STATE OF NORTH CAROLINA
DEPARTMENT OF TRANSPORTATION

Subject: Modification Request for the Individual Section 404 Permit, Individual Water Quality Certification, and Tar-Pamilico Buffer Authorization for the Rocky Mount Northern Connector, from SR 1604 (Hunter Hill Road) to US 301, Nash County, TIP No. R-2823, Debit \$570 from WBS 34509.1.1.

In an application dated December 17, 2008, the North Carolina Department of Transportation (NCDOT) submitted an Individual Permit application for the Subject project. This application requested authorization for impacts to jurisdictional features based upon a final design prior to an additional public meeting presenting the final design, held on October 28, 2008. Based upon comments from the meeting and subsequent inquiries from the public concerning the traffic flow from Station -L- 27+45 to Station 65+55, the roadway was re-designed to include directional crossovers and four bulb U-turns to provide additional left-turn traffic flow along Woodruff Road. The redesign will result in unavoidable impacts to Waters of the U.S. Revised permit drawings, buffer drawings and roadway plans are included with this modification request.

REVISED 06/10/99
BUFFER DRAWING
SHEET 34 OF 56

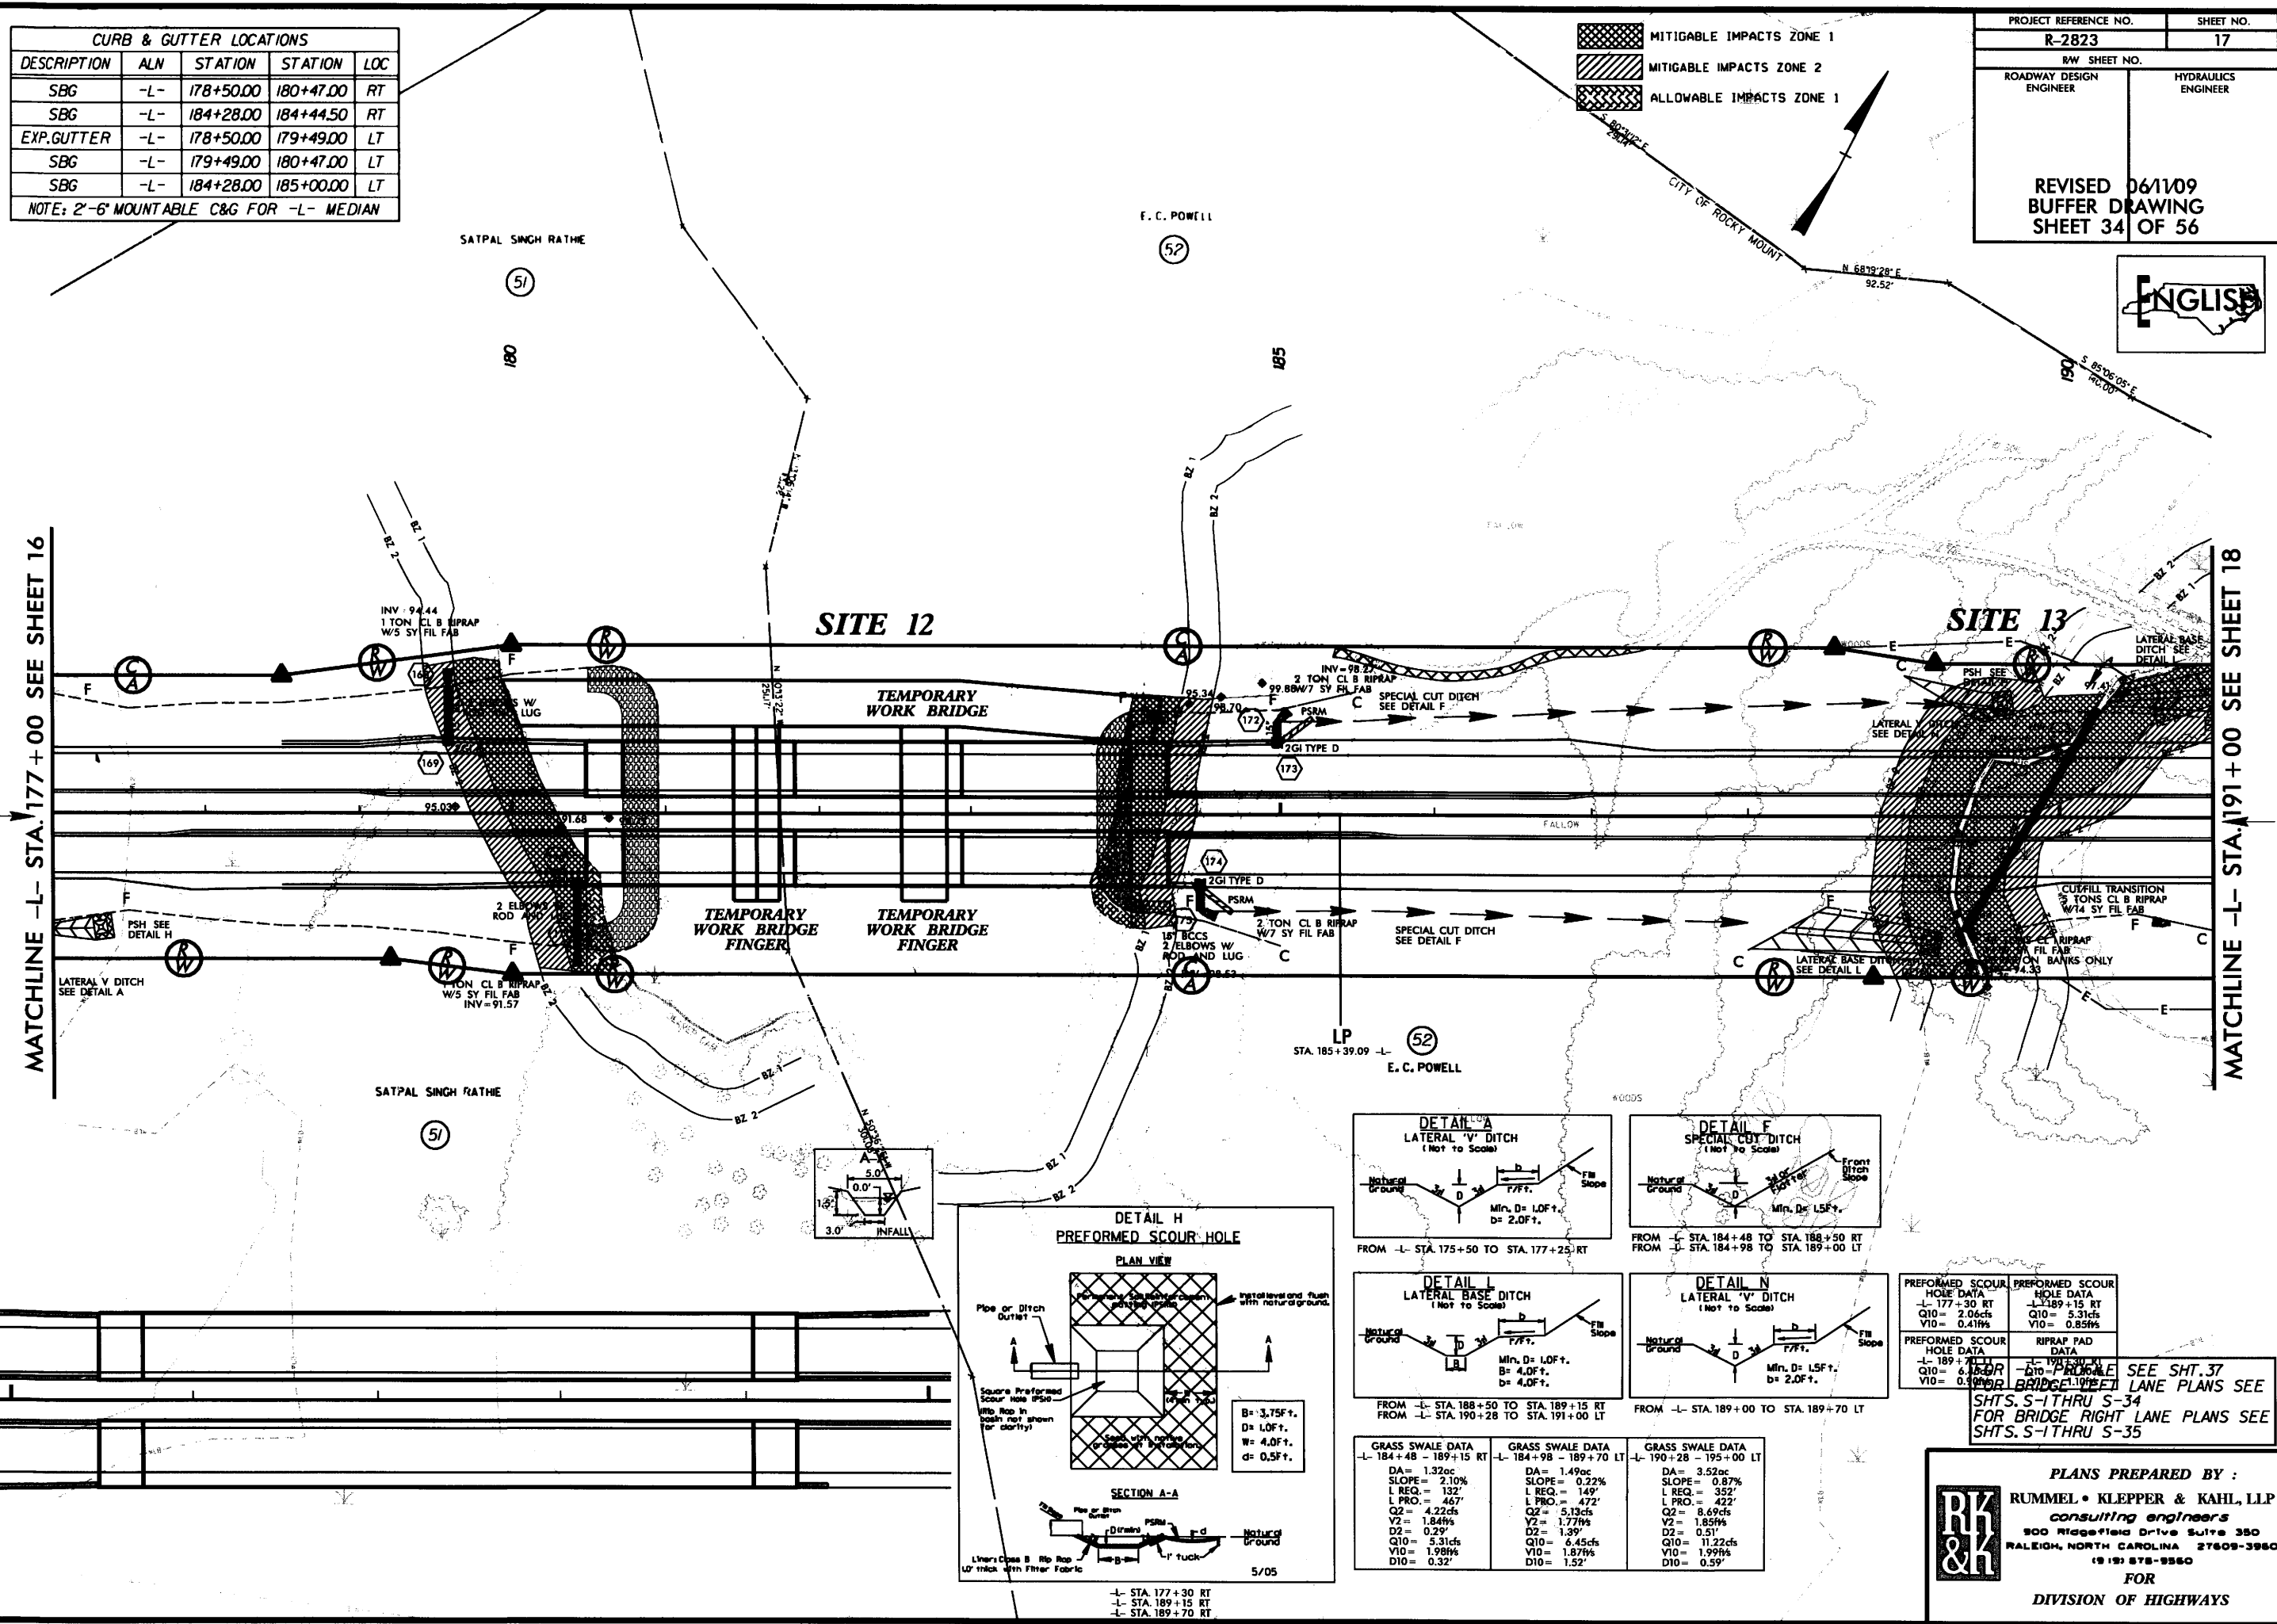
The revised drawings (Permit Sheets 43 and 44 of 68 and Buffer Sheets 34 - 37 of 56) indicate that impacts at Site 13 will change due to a pipe clearance profile change. The profile was modified slightly at 189+90 to increase the amount of fill on top of the pipe to reduce possible maintenance issues for the pipe and road in the future. A summary of the original and revised impacts is provided in the following table.

Impact Description	Dec. 17, 2008 Impact	Revised Impact	Impact Change
Fill in Wetlands	0.21 Ac	0.26 Ac	+0.05 Ac
Excavation in Wetlands	0.02 Ac	0.02 Ac	None
Mech. Clearing in Wetlands	0.06 Ac	0.05 Ac	-0.01 Ac
Perm. Surface Water Impacts	0.01 Ac (205 LF)	0.02 Ac (218 LF)	+13 LF
Temp. Surface Water Impacts	0.00 Ac (43 LF)	0.01 Ac (75 LF)	+32 LF
Wetlands in Buffer Zone 1	9,708 sq ft	10,132 sq ft	+424 sq ft
Wetlands in Buffer Zone 2	2,521 sq ft	2,661 sq ft	+140 sq ft
Mitigable Buffer Zone 1	15,653 sq ft	16,082 sq ft	+429 sq ft
Mitigable Buffer Zone 2	10,114 sq ft	10,345 sq ft	+231 sq ft

SITE 13
REVISED 06/11/09
BUFFER DRAWING
SHEET 44 OF 56

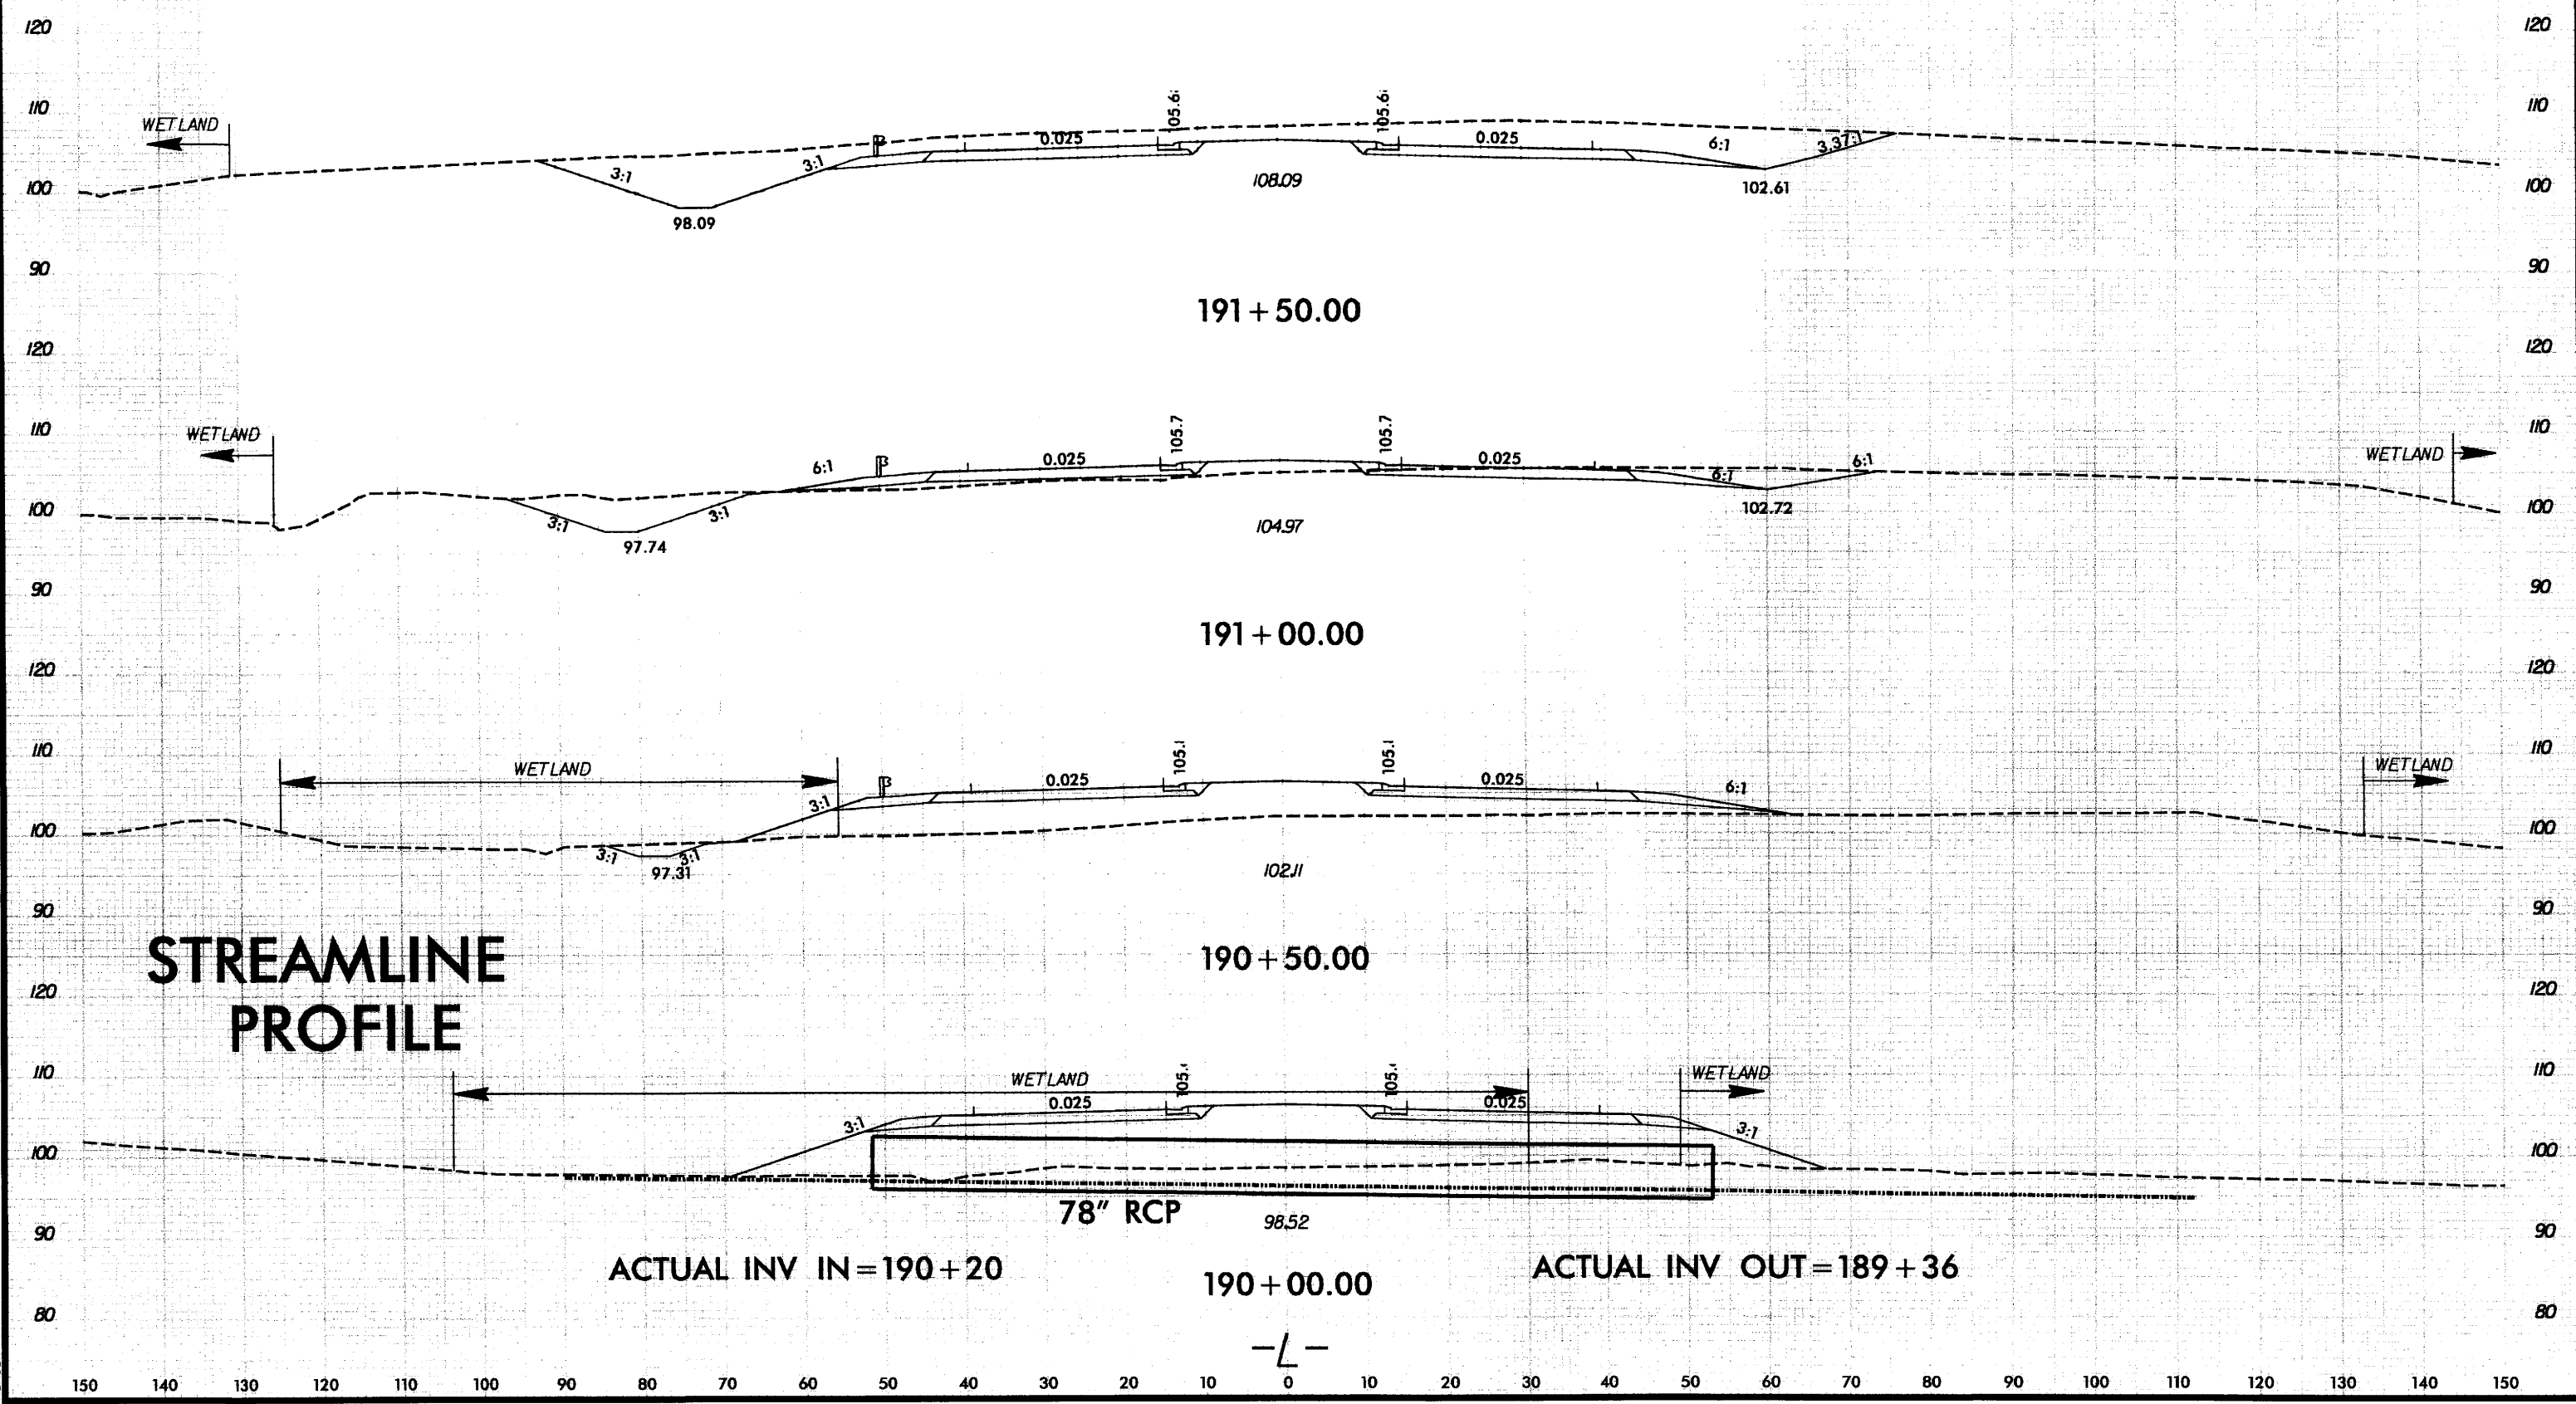
Revised profile and cross section permit sheets 45, 50 and 51 of 68 (buffer sheets 38, 43 and 44 of 56) are enclosed.
